Product information - BMW brake pads | HELLA

BMW brake pads

8DB 355 009-271 / 8DB 355 015-391

New allocation of the brake pads

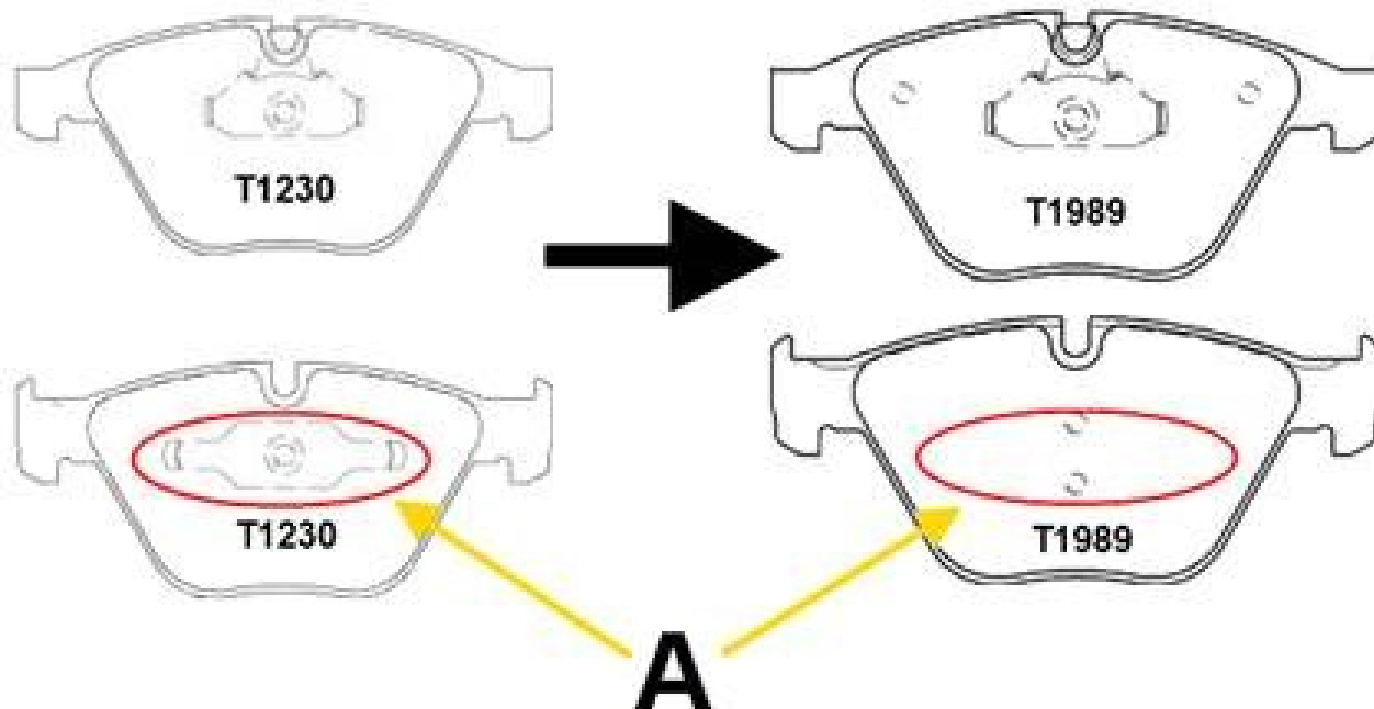
The difference between both brake pads is the missing retaining spring (A) on the brake pad 8DB 355 015-391 / T1989 on the fist side.

All other models are now covered by 8DB 355 015-391 / T1989. 8DB 355 015-391 / T1989 can also be retroactively used for all vehicles linked.
